Agenda Date:	June 27, 2019	Application ID:	SP 2019-06
Project:	Diversified Aviation Phase IIA	Project Number:	PRJ 2019-08
Project Planner:	Joseph Yaciuk, Planning Administrator		
Owner:	Cary Goldberg	Agent:	Barranco Gonzalez Architecture
Location:	North of Pembroke Road and west of Southwest 72 Avenue		
Existing Zoning:	A-1 (Limited Agricultural)* (Existing Airport)	Existing Land Use:	Transportation
Reference Applications:	SP 2011-18, ZV 2011-50, SP 2012-12, SP 2014-23		
Applicant Request:	Amending a previous site plan to allow for the construction of two new Hangars to replace three previously approved and unbuilt hangars.		
Staff Recommendation:	Approval, subject to the applicant providing LED lighting fixtures that do not exceed 3000k Correlated Color Temperature (CCT) in compliance with City of Pembroke Pines lighting code.		
Final:	<input checked="" type="checkbox"/> Planning & Zoning Board	<input type="checkbox"/> City Commission

Re: SP 2019-06 (Diversified Aviation)

PROJECT NAME: Diversified Aviation at NPA – Ph. IIA

PROJECT NAME: **Diversified Aviation at North Perry Airport –Phase IIA;**
SP2019-06

B6 CODE ANALYSIS

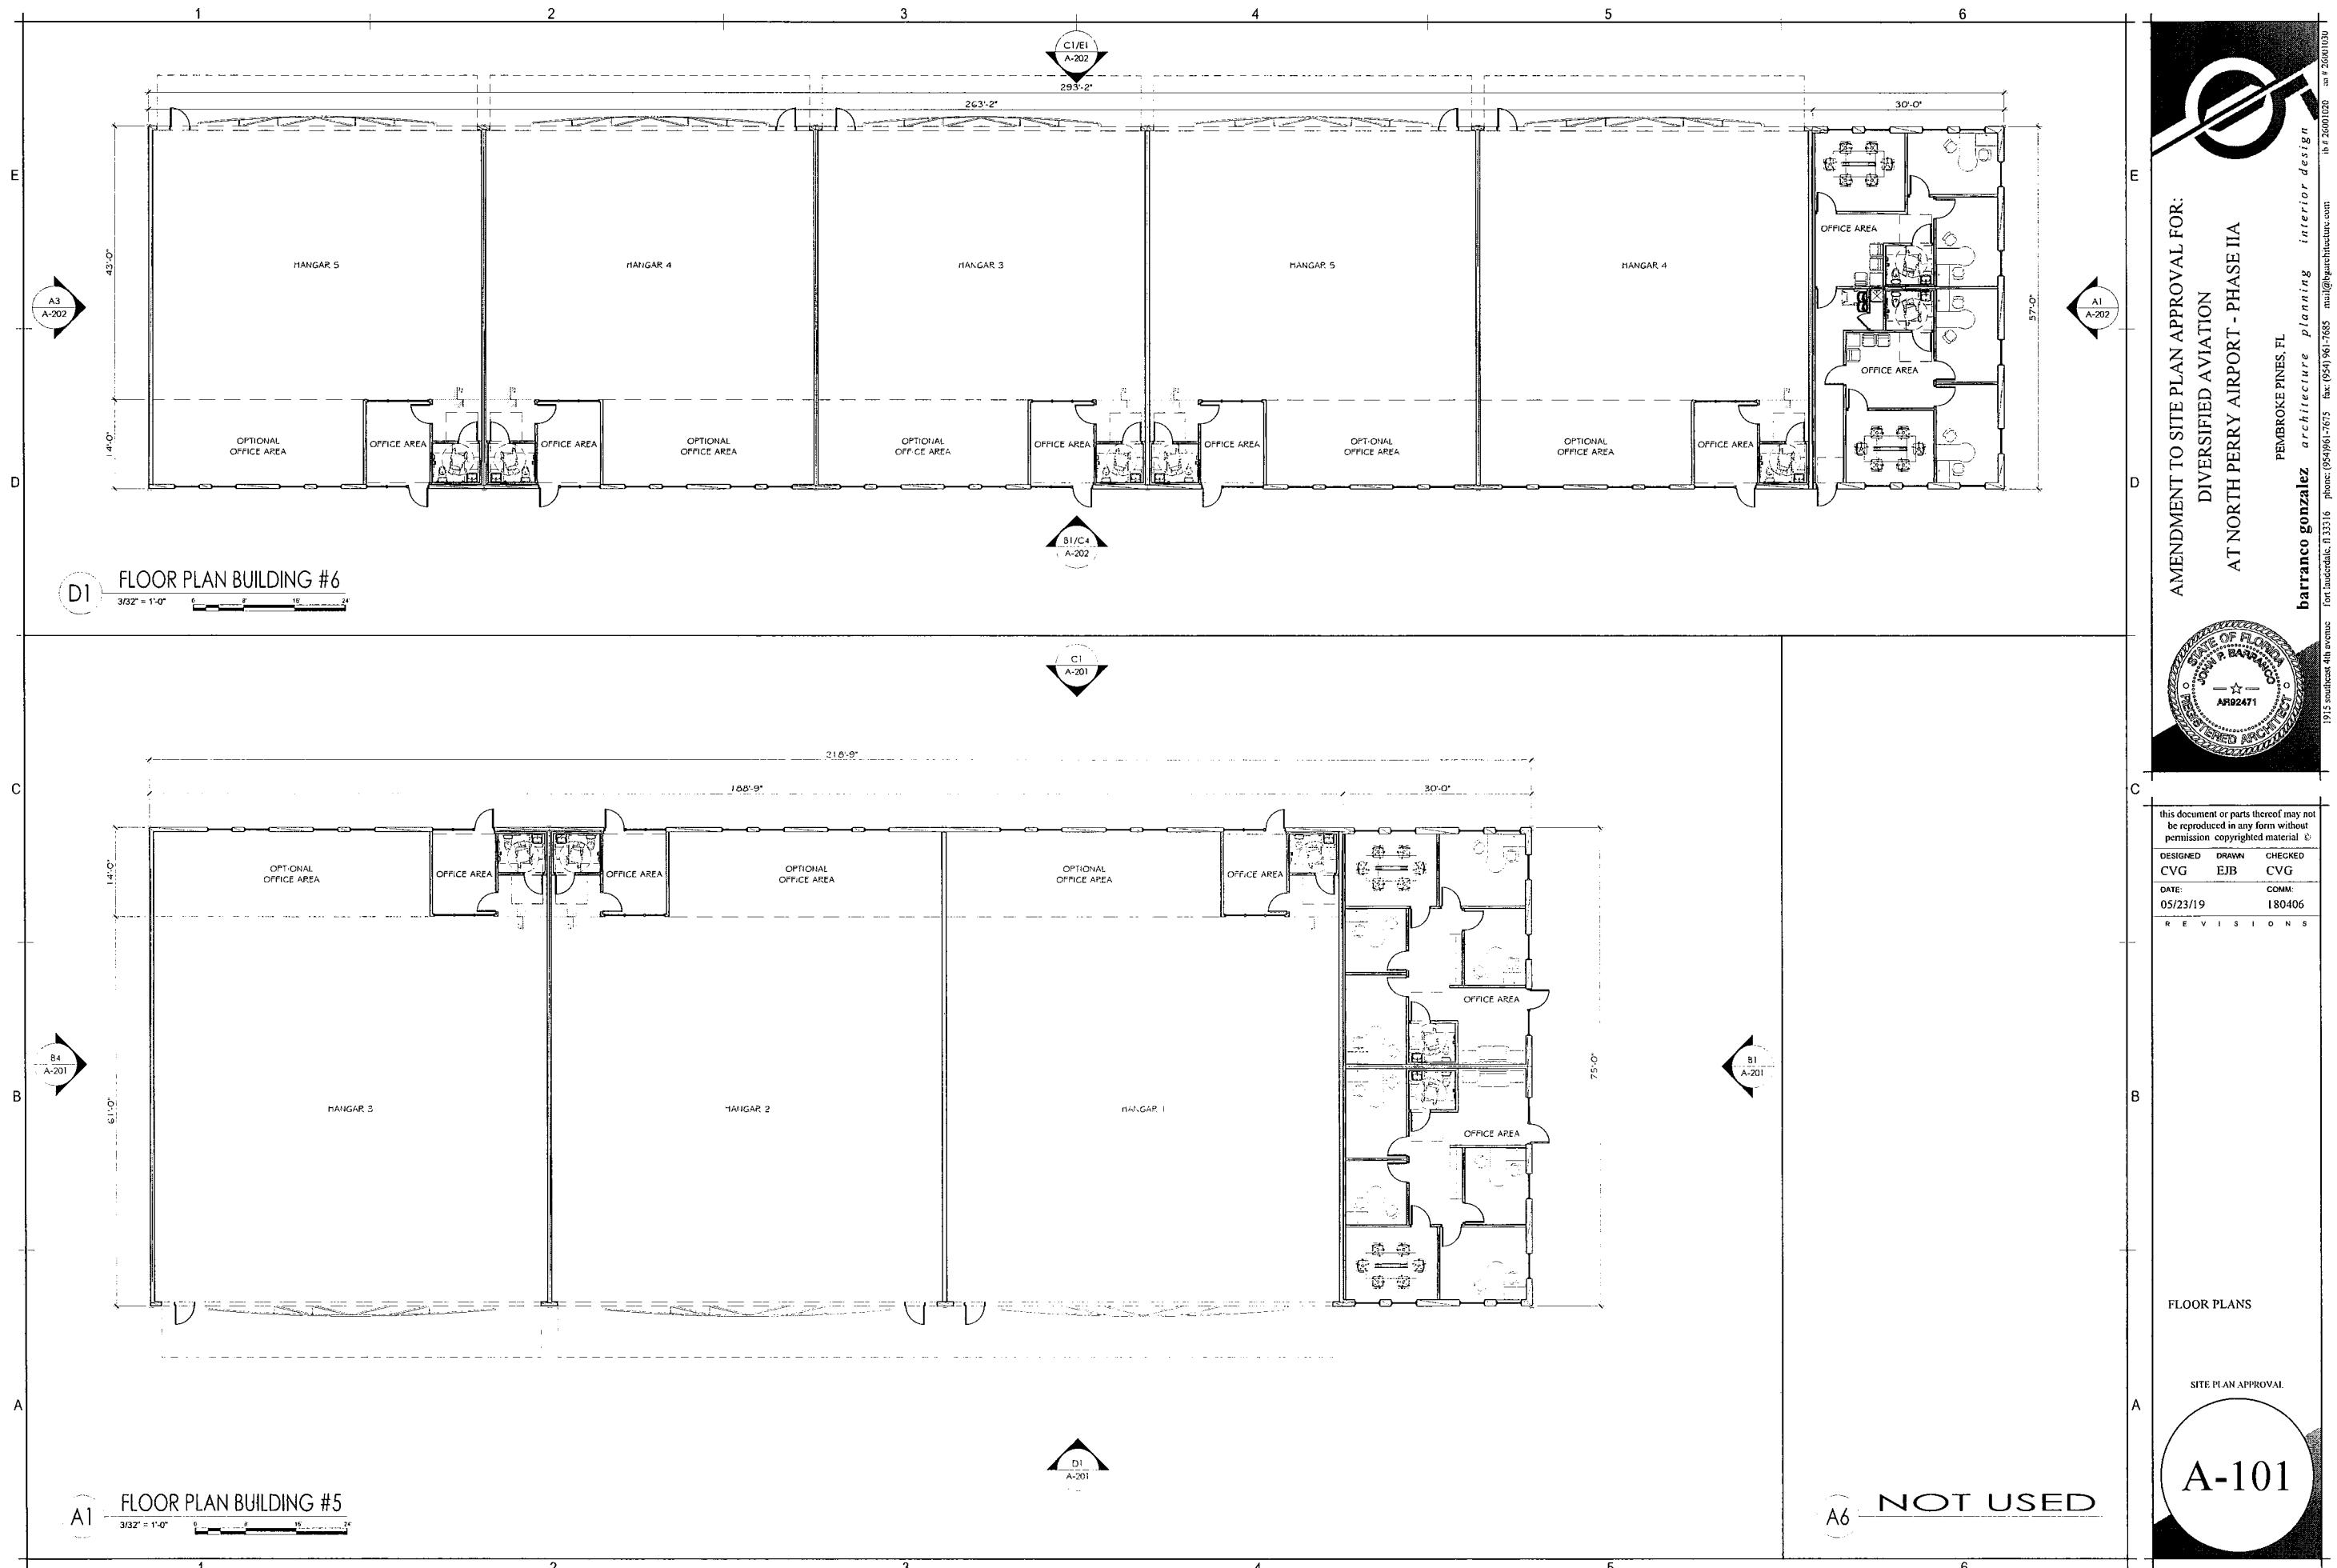
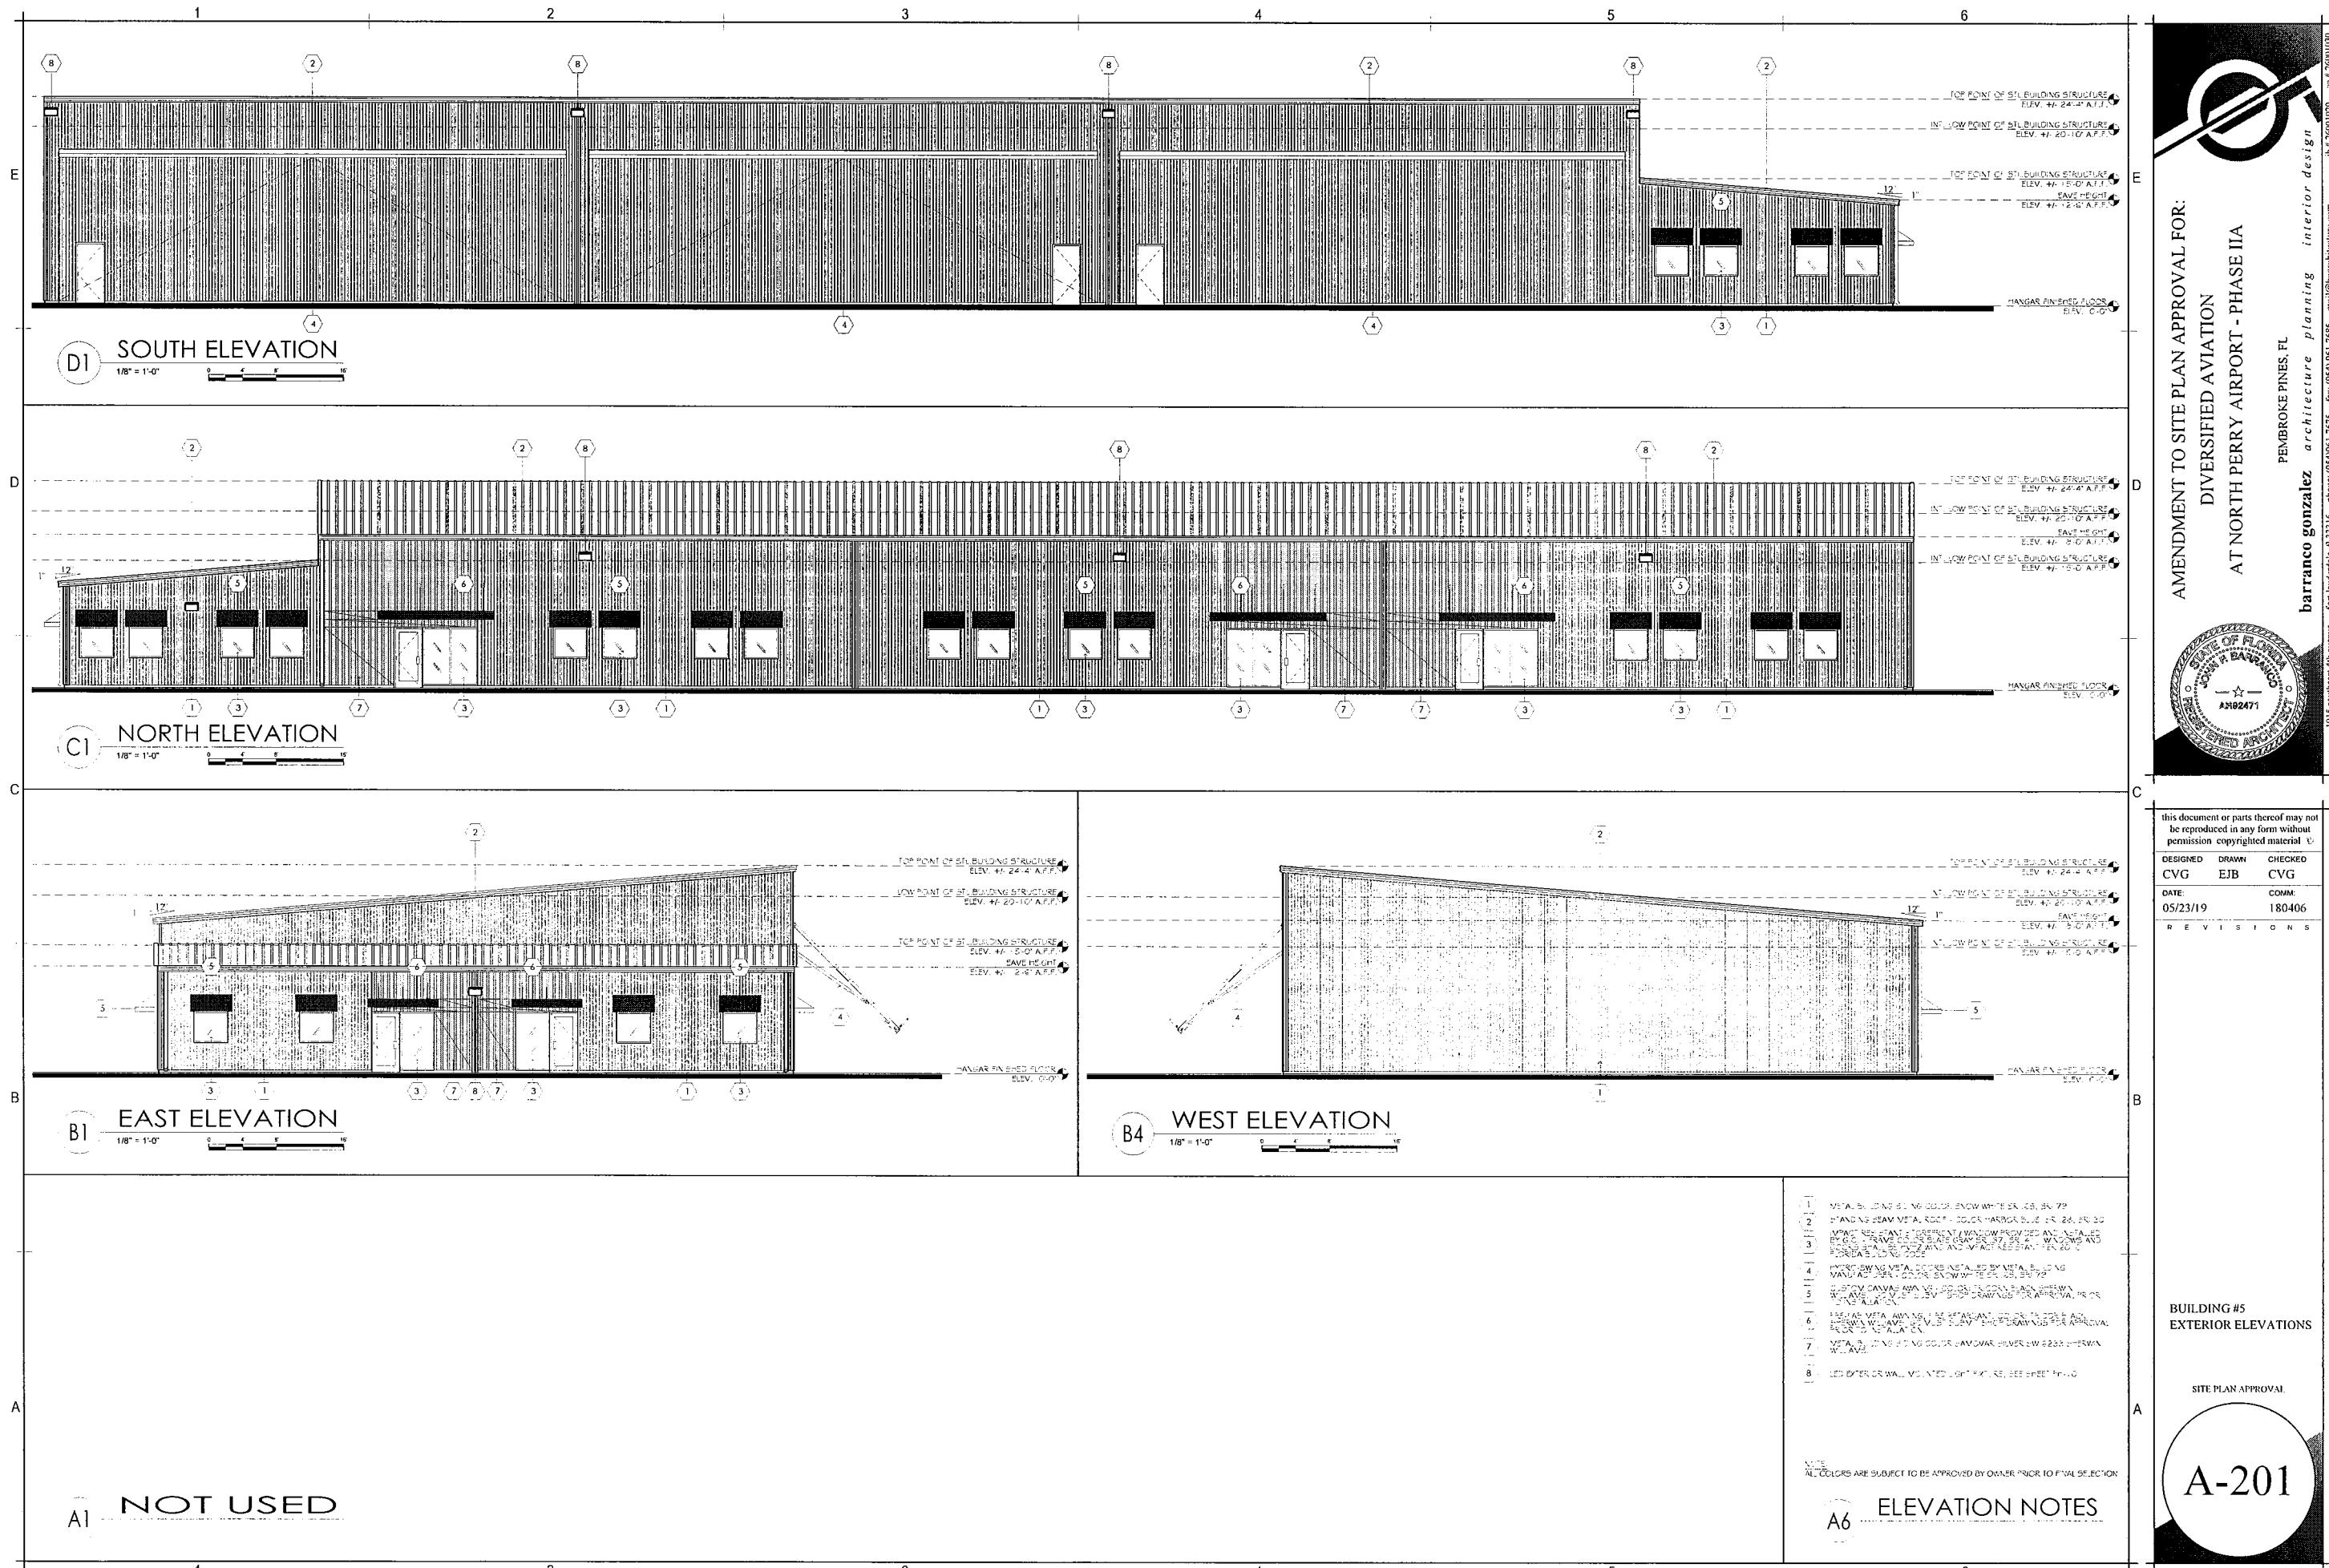
1. Has this revision been reviewed by BCAD? Provide BCAD's comments.
2. On page A101 show Fire Codes in effect: Florida Fire Prevention Code (FFPC) 6th edition with Broward County Amendments, which includes NFPA 101, 2015 edition, NFPA 1, 2015 edition, & State Statutes, 2018 edition. NFPA 409, 2011 edition, FBC 6th edition. (Adopted referenced publications found herein.)

3. Insufficient building data information provided on plans. On sheet A101, please declare Aircraft Hanger Classification Group Type and Construction Type on Plans. (NFPA 409: Chapter 4 and 5, 2011 Edition).

4. Declare on sheet A101 of strictly storage or will there be servicing of aircrafts as well.
5. Show fire hydrant placement on sheet A101.
6. Fire hydrant show on the north side of building 6 appears to be on the airside of the building; if so, provide detail of height clearance for aircraft wing span.

8. Dead end fire department access roads in excess of 150 feet in length shall be provided with approved provision for the fire apparatus to turn around. See the north side of building 6. Please address. NFPA 1: 18.2.3.4.4.
